**WHEELING PLAN COMMISSION
THURSDAY, NOVEMBER 2, 2017 6:30 P.M.**

REQUEST FOR PLAN COMMISSION ACTION
STAFF PROJECT REVIEW

RE: **Docket Nos. 2017-15 & PC 17-18**
Uptown 500 (formerly Uptown 501)
500 W. Dundee Road (formerly 500 W. Dundee Road)
(2017-15) Final Planned Unit Development Approval of a
Mixed-Use Retail and Residential Development
(PC 17-18) Approval of a Preliminary Plat of Subdivision
(SCBA 17-43) Appearance Approval of Freestanding Signs

DATE OF REPORT: October 30, 2017

Dundee Road Elevation

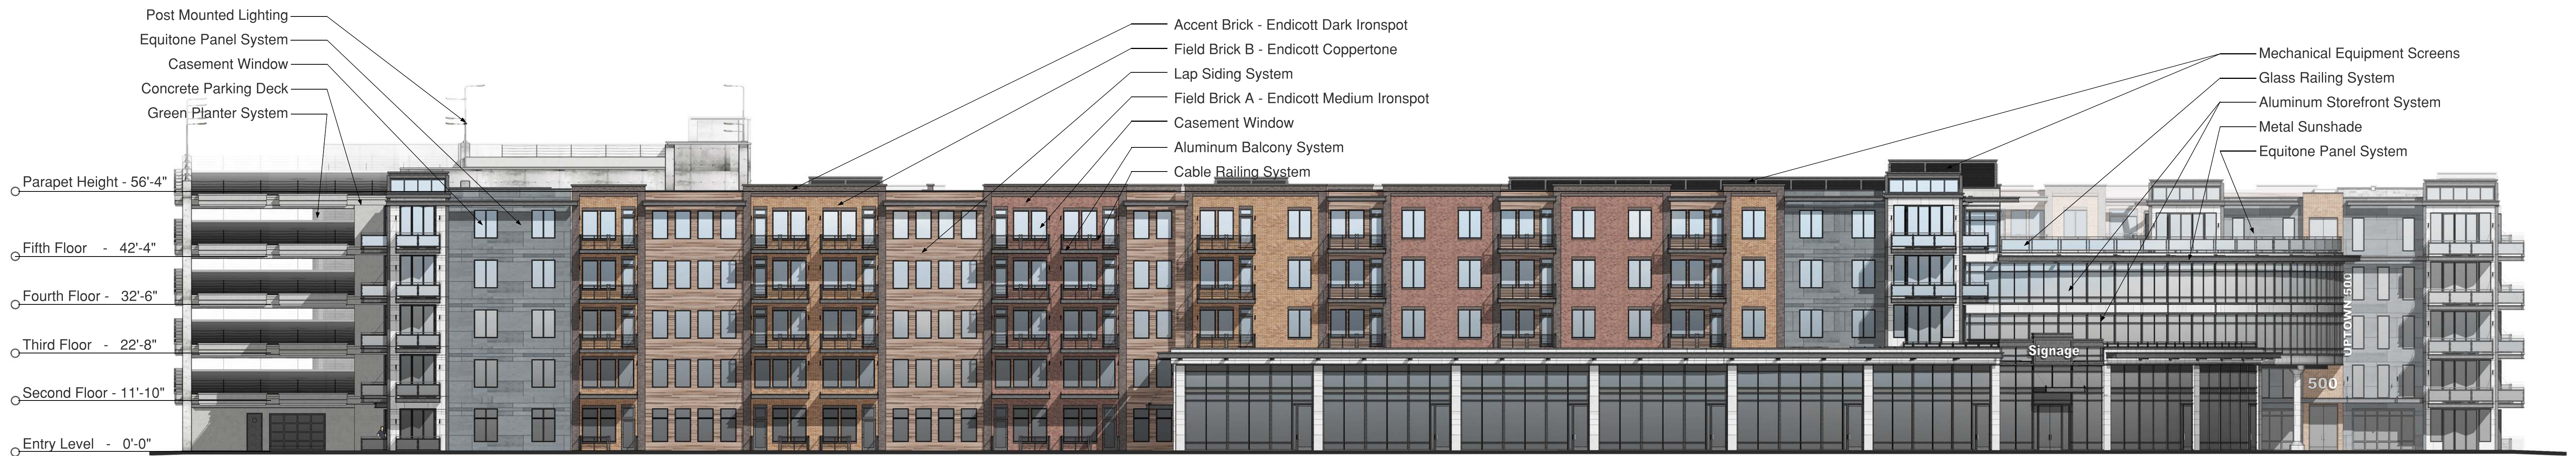
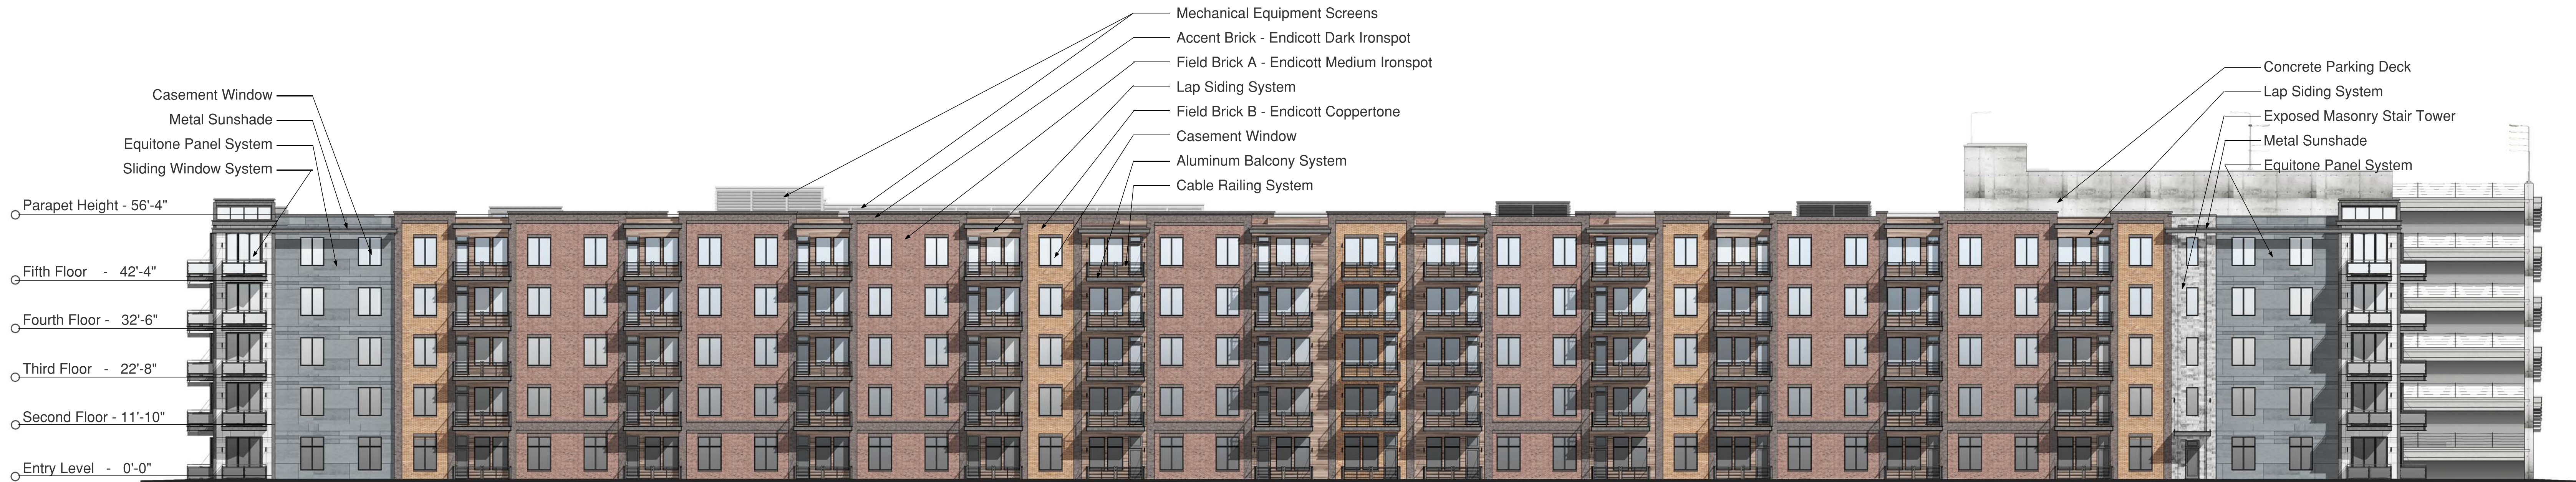
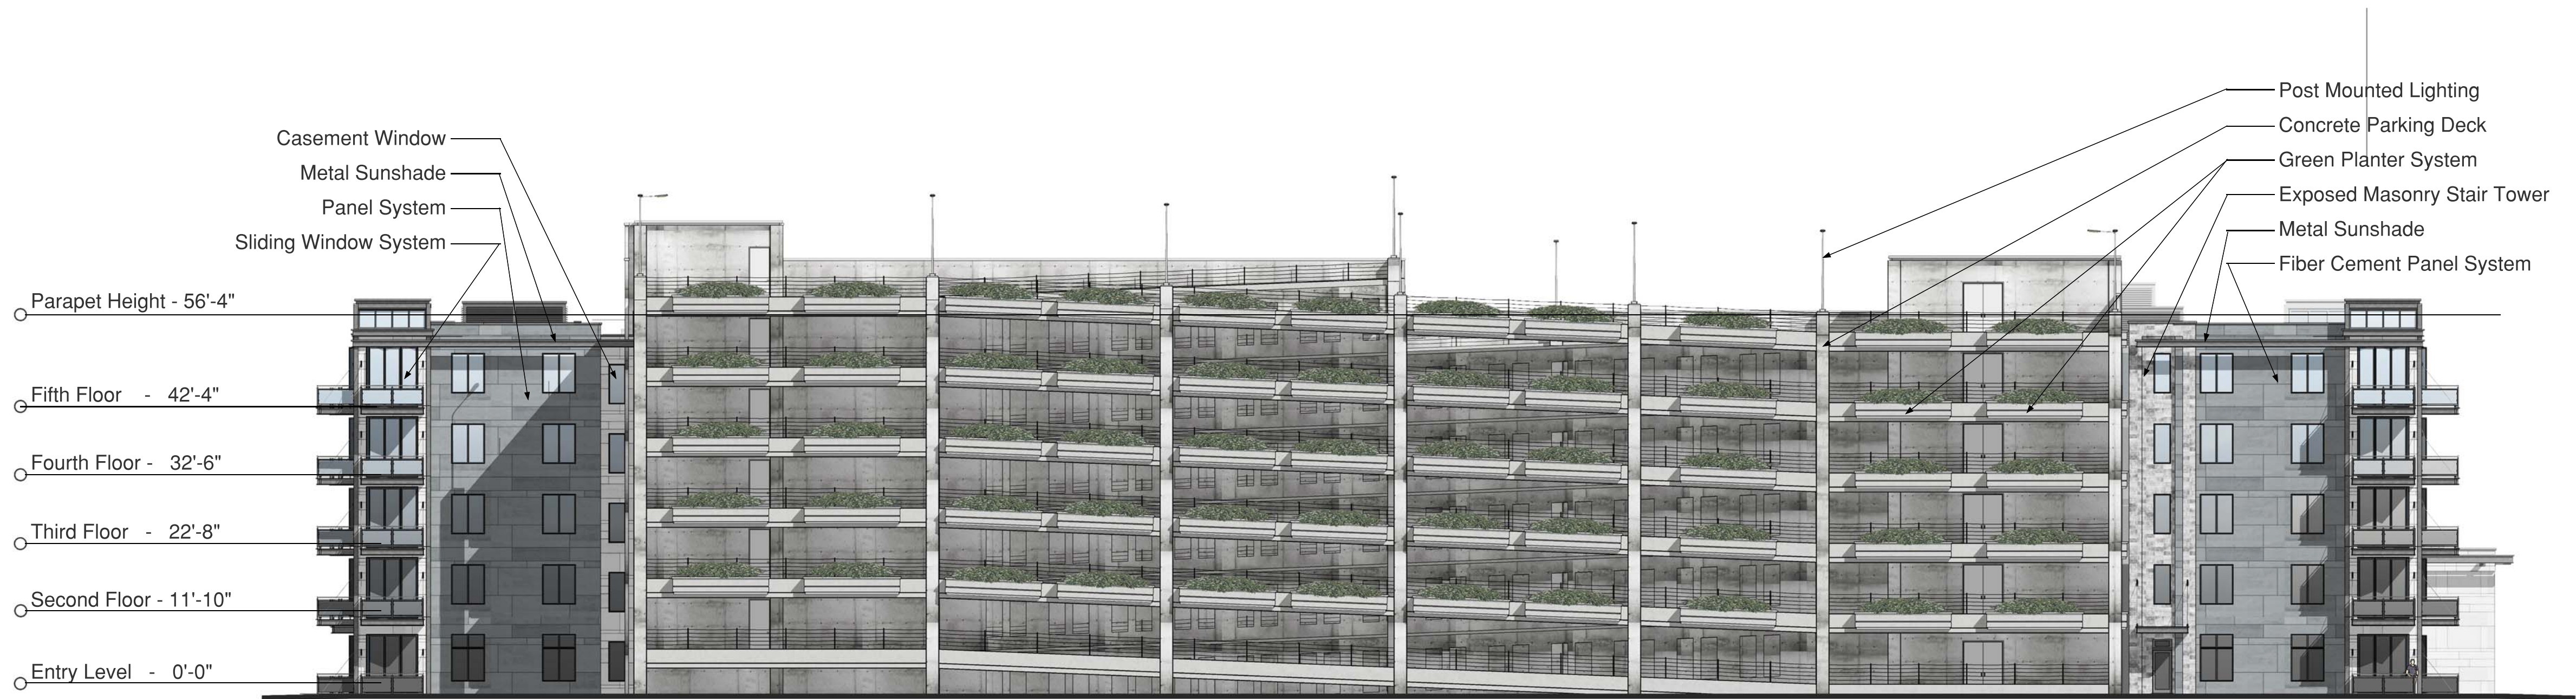
The exact building height is not clearly identified in the elevation plans. The proposed structure has a height of approximately 60 feet and is five stories. The top of the parapet is listed at 56'4". The top of the mechanical screenings is 59'8". However, according to the project architect, the garage stair tower and/or elevator shafts may be at high as 64 feet. Staff suggests the PUD identify height variations to allow for the main building height of 60 feet and for the garage stair towers and/or elevator shafts to have heights of 64 feet.

Elevation Plan Review: The building’s mass is broken up by the glass storefront area, outdoor terrace space, and vertical bands of balconies. The primary building materials include a field brick and a lap siding system alternating in the large areas in between the balconies. Per the Plan Commission request at Preliminary PUD, the field brick and accent brick are masonry, not cement panels. However, the “Lap Siding System” is not clearly defined. It was previously shown as Fiber board panels. The Elevation Plans also show an aluminum balcony system, a metal sunshade, a glass railing system on the upper level, a glass and aluminum storefront system on the retail area and residential amenity complex, and an “Equitone Panel System” alternating throughout. The Plan Commission may wish to seek more information about the “Lap Siding System” and “Equitone Panel System.”

Level 1

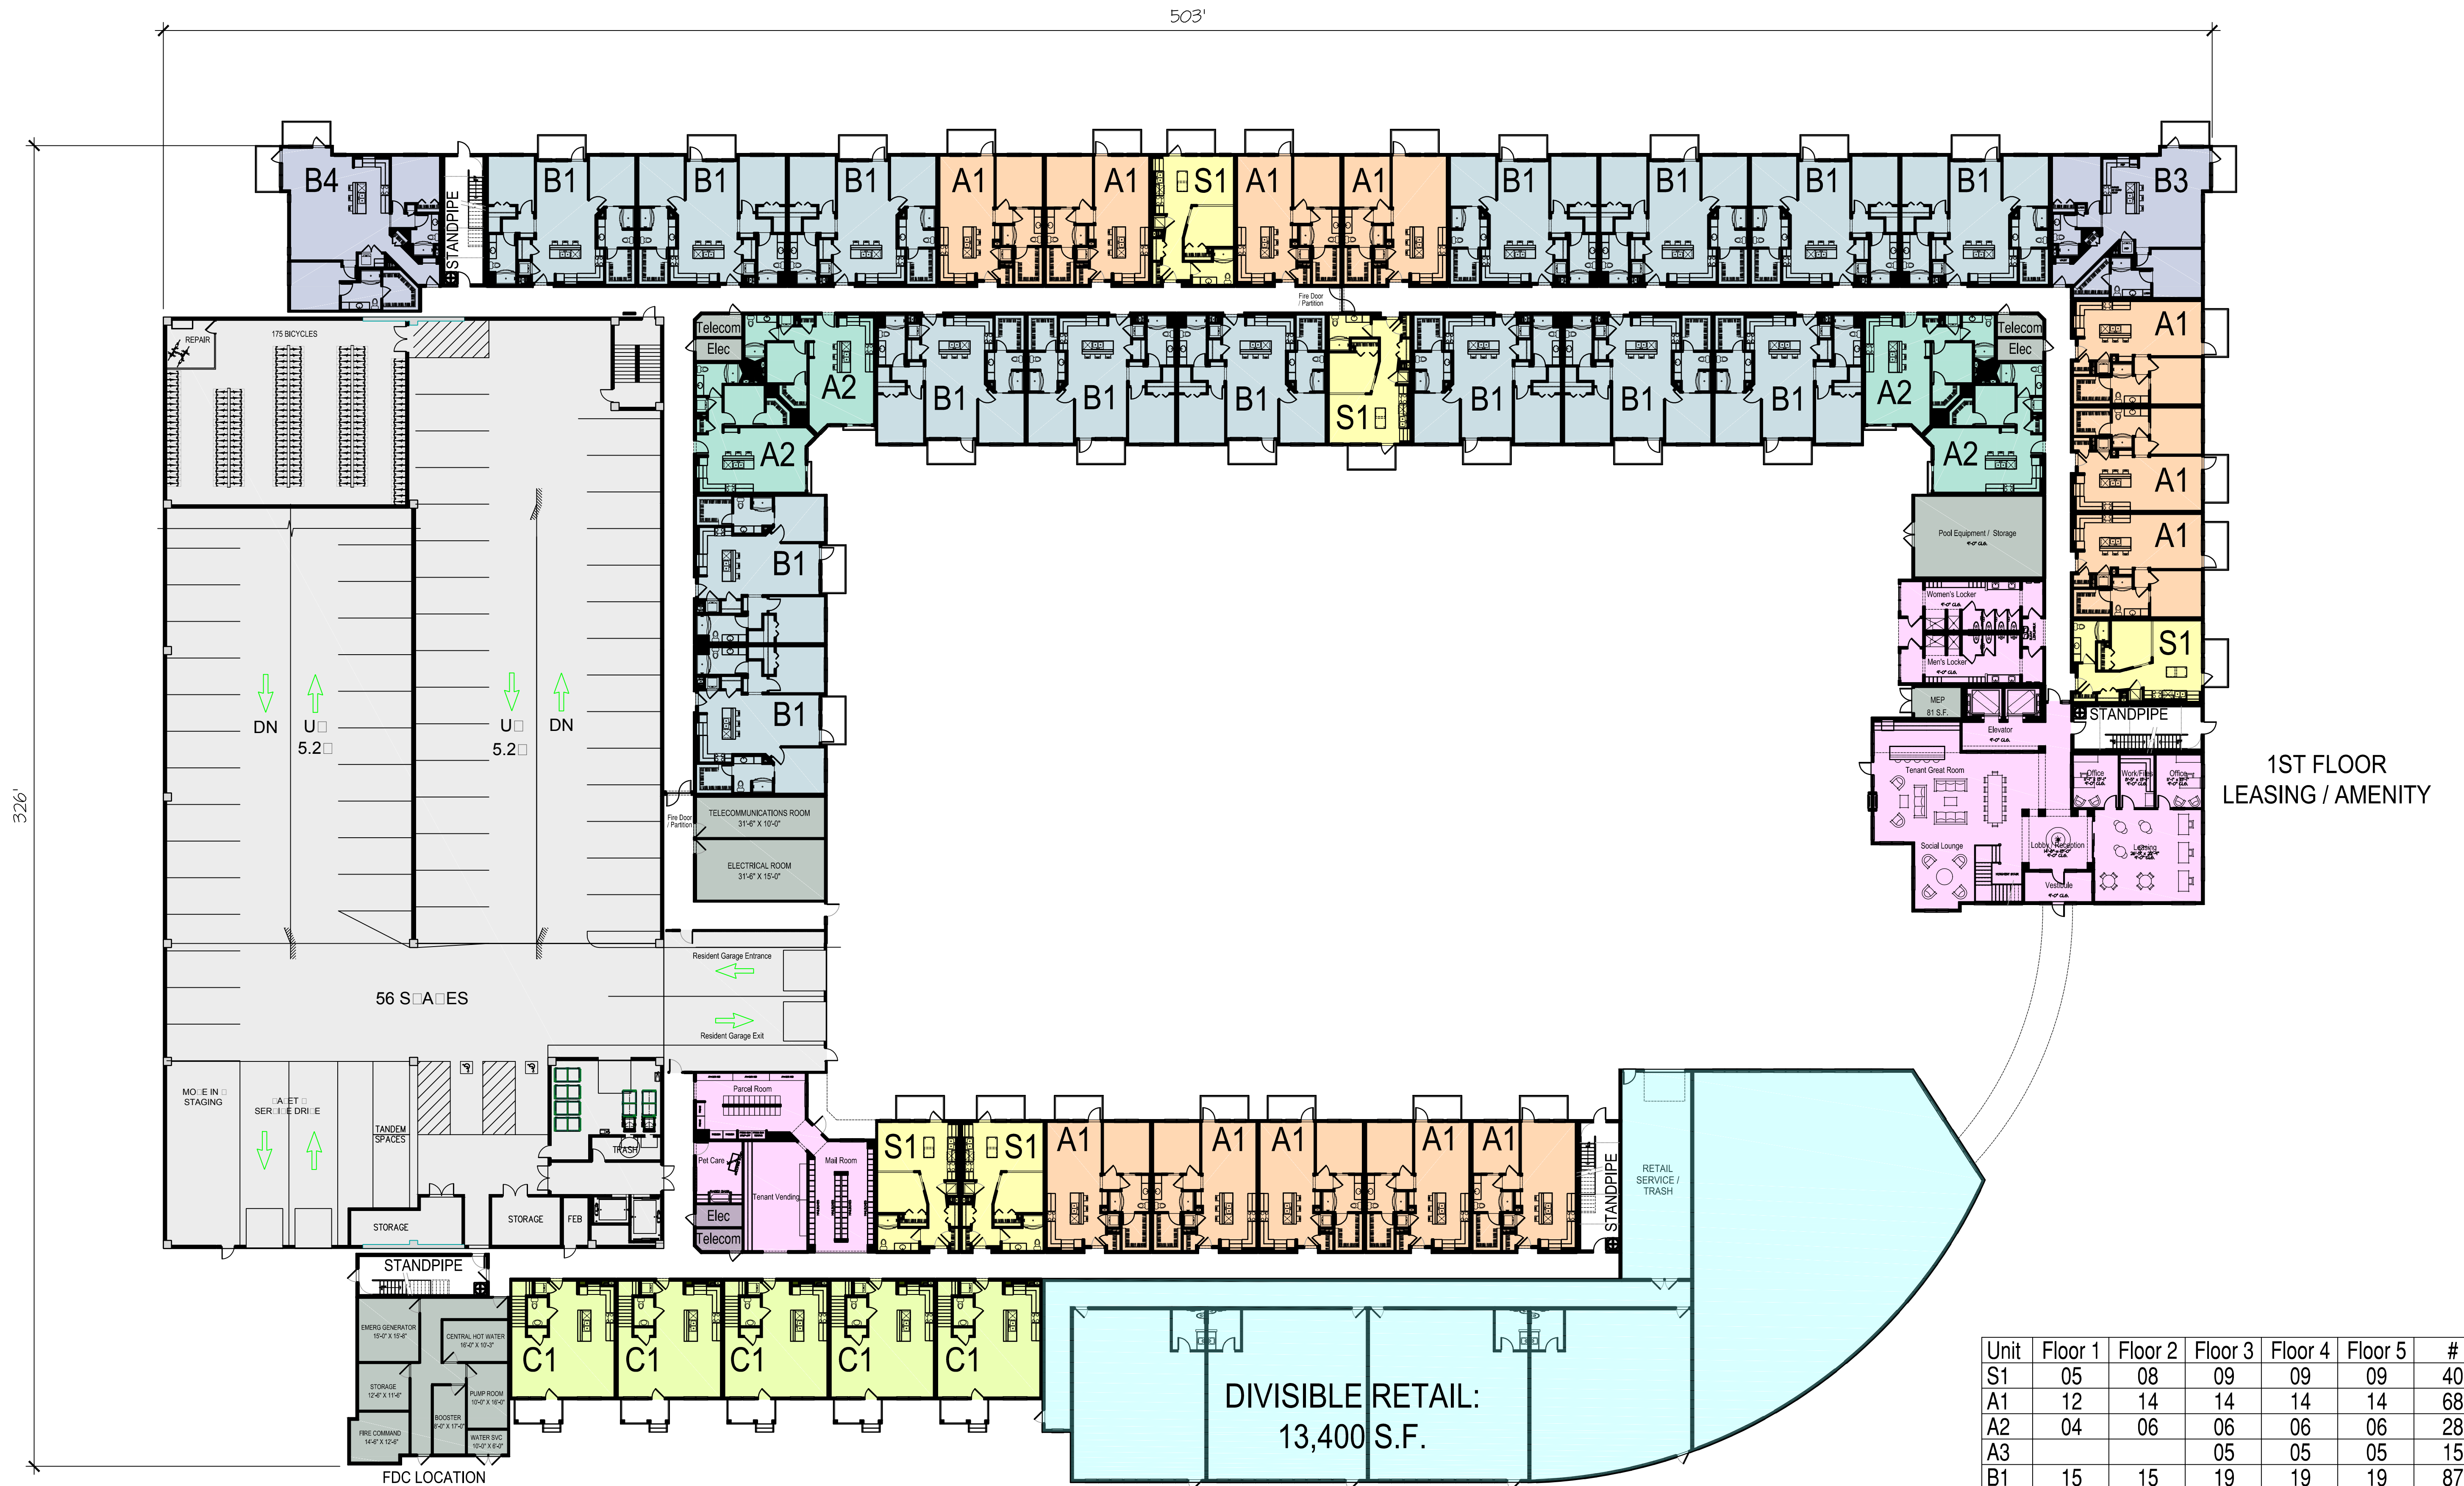
Bicycle Parking: The variation data sheet indicates that the building will accommodate storage for 132 bicycles for residents. However, the first floor plan shows bicycle locker room with storage for 175 bikes and a bike repair shop. The code requires one bicycle parking space for every two residential units. Notations for bike racks are also shown on the site plan at each end
